Applicant's Name: Hoaani Merritt & Paige Olsen	Date: 10/06/2021 Start time: 10.30	Date: 7 Oct 2021 Re-Inspection Start time: 1030
Property Address: 37 Symonds Road	Inspection Number: 1	Phone: 0274 595 865 (07)3084584 Email: hoaani.merritt@outlook.co.nz
ITEMS TO BE CHECKED TAKE PHOTOS		
Key: Decision: ✓ or P = Pass X or F = Fail, further inspection required I or — or NA = Not Applicable Reason for decision: Compliance or non-compliance with the approved building consent documents		
ALL POOLS	1 st	2 nd
FENCING		
Fencing (incl. walls) continuous around pool	P	
Fence at least 1200 mm high above ground	P	
Mesh or trellis fence with gaps larger than 10mm (But less than 50mm) to be at least 1.8 metres high	NA	
Horizontal rails on outside of the fence (if any) >900 mm apart	NA	
No climbable objects within 1200 mm of the outside of the fence	P	
No gaps > 100 mm in fence (or >50 mm if mesh/trellis) (Includes Cat/Dog doors in windows/walls of building)	P

10/06/2021 – Met Hoaani onsite. New pool fencing glass and metal installed but not completed.

Figure 1 - 7 Oct 21 - glass access gate not self-closing.

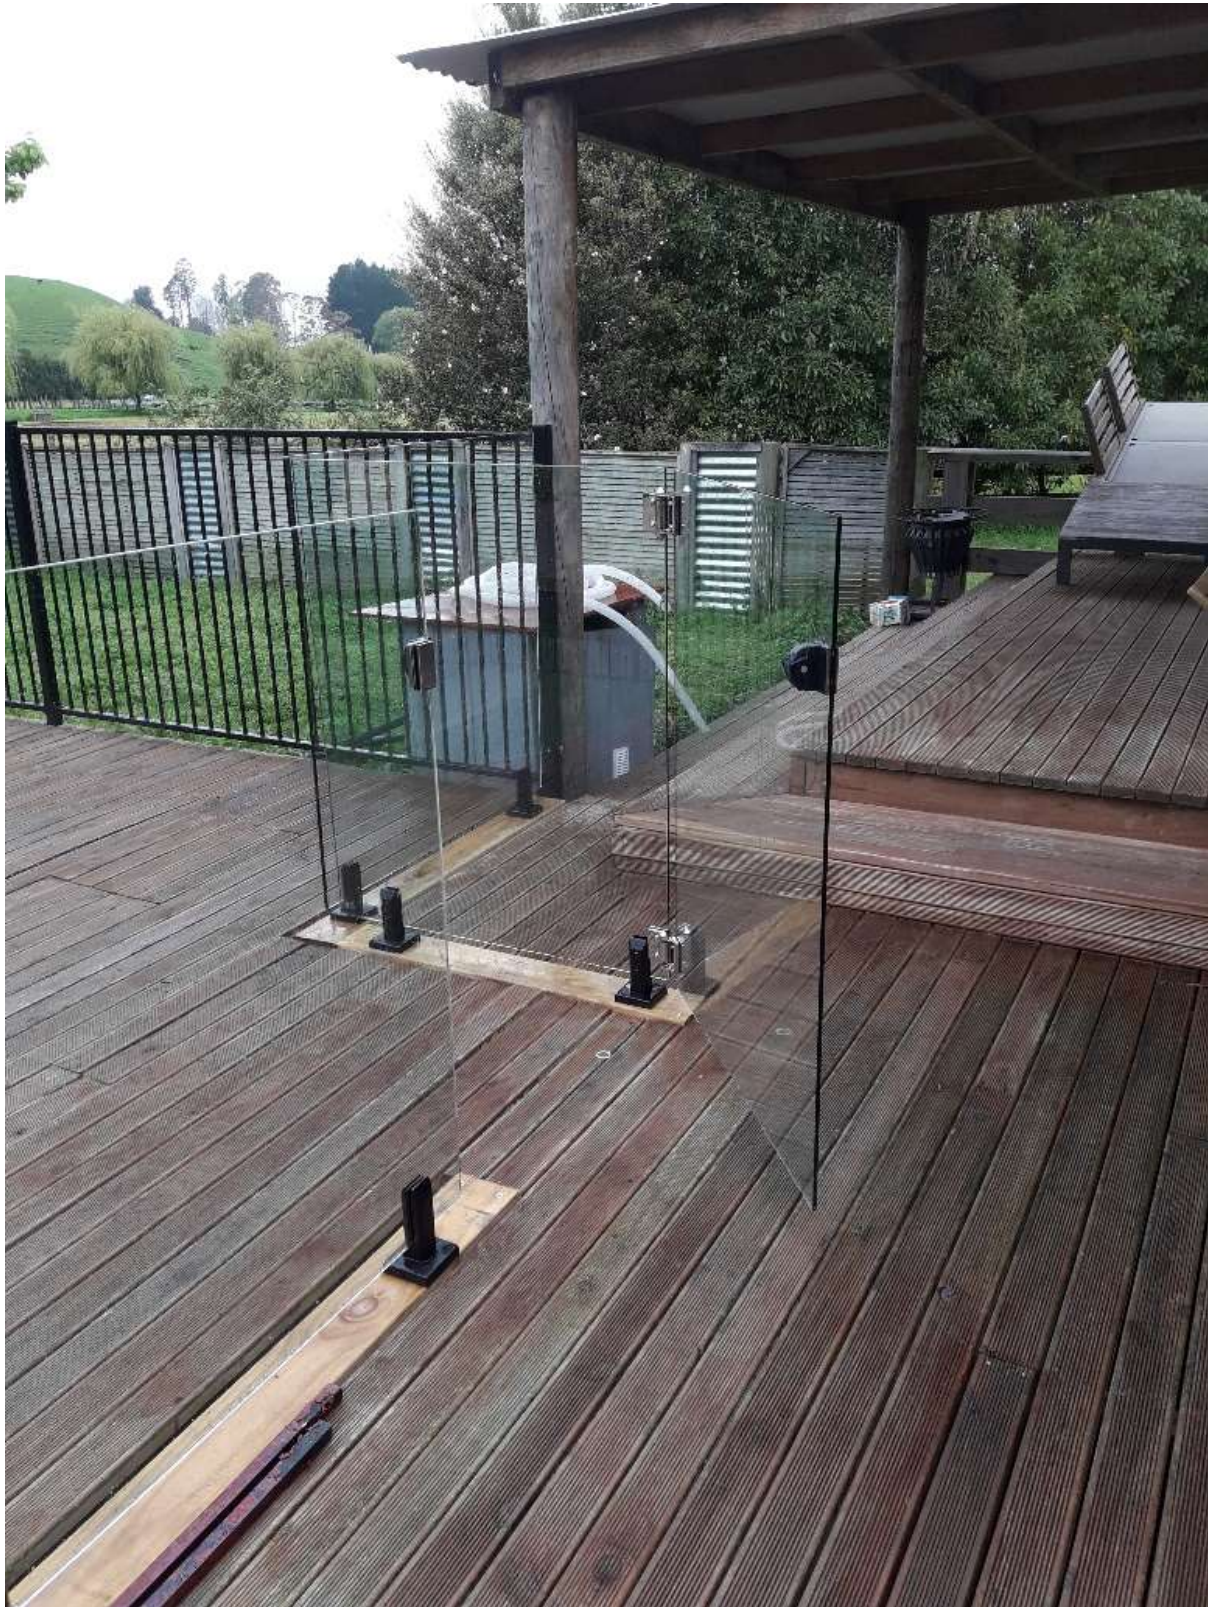
- 1) Fit the self-closing latches to both glass access doors of the pool perimeter fencing as soon as they are obtained. The doors to self-close, self-latch from any position (150mm min) and be unable to be shaken.
In the interim, install a suitable temporary “locking system” to the glass gates.
- 2) Install BFPD

Paige explains by phone that the work has been unable to be done due to Covid. The glass pool access gate to the East is still not self-closing/self-latching. The other glass gate is decommissioned to be an access gate at this inspection.
